Access Compliance Report

Public Rights-of-Way

(Curb Ramps)

Intersection ID: 45834	Main Street: PATRICIA_ANN_LN	Cross Street: KELDEN_WALKER_LN	Location: SE
ADA ID: BDAE1FE75221	Ramp Type: PerpDiag	Initial Pass/Fail: Fail	Overall Compliance: No
Severity Score: 22.5			
Codes/Mitigation Info/Possible Solution		Field Measurements/Component Compliance

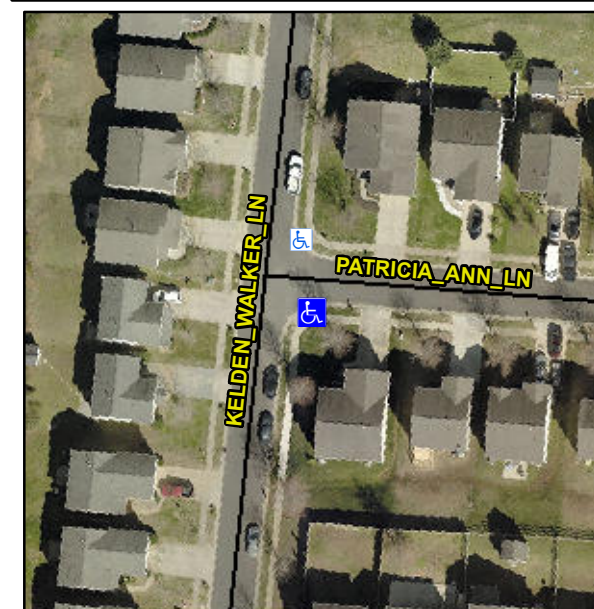
Not Found, R304.5.1, R304.2.2, R304.5.3

Compliance	Description	Data	Compliance	Description	Data
N/A	Ramp Length (in)	47.5	No	Ramp Slope (%)	9.2
No	Ramp Width (in)	37.0	No	Ramp XSlope (%)	3.9
N/A	Flare Type LT	N/A	N/A	Flare Type RT	N/A
N/A	Flare Slope LT (%)	N/A	N/A	Flare Slope RT (%)	N/A
N/A	Flare Traversable LT?	N/A	N/A	Flare Traversable RT?	N/A
N/A	Landing Length (in)	N/A	N/A	DWS Provided?	N/A
N/A	Landing Width (in)	N/A	N/A	DWS Contrast?	N/A
N/A	Landing Slope (%)	N/A	N/A	DWS Length (in)	N/A
N/A	Landing X Slope (%)	N/A	N/A	DWS Full Width?	N/A
N/A	Landing Curb? (Y/N)	N/A	N/A	DWS Offset (in)	N/A
N/A	Shared Landing?	N/A			
N/A	Gutter Ponding?	N/A	N/A	Gutter Slope (%)	N/A
N/A	Gutter Lip Ht (in)	N/A	N/A	Gutter X Slope (%)	N/A
N/A	Painted X Walk1?	No	N/A	Painted X Walk2?	No
	X Walk 1 Direction	To N		X Walk 2 Direction	To W
N/A	X Walk 1 Width (in)	N/A	N/A	X Walk 2 Width (in)	N/A
	X Walk 1 Slope (%)	4.7		X Walk 2 Slope (%)	0.2
	X Walk 1 X Slope (%)	1.6		X Walk 2 X Slope (%)	3.3

Remove & Replace Curb Ramp With Two New Directional Ramps or Equivalent.
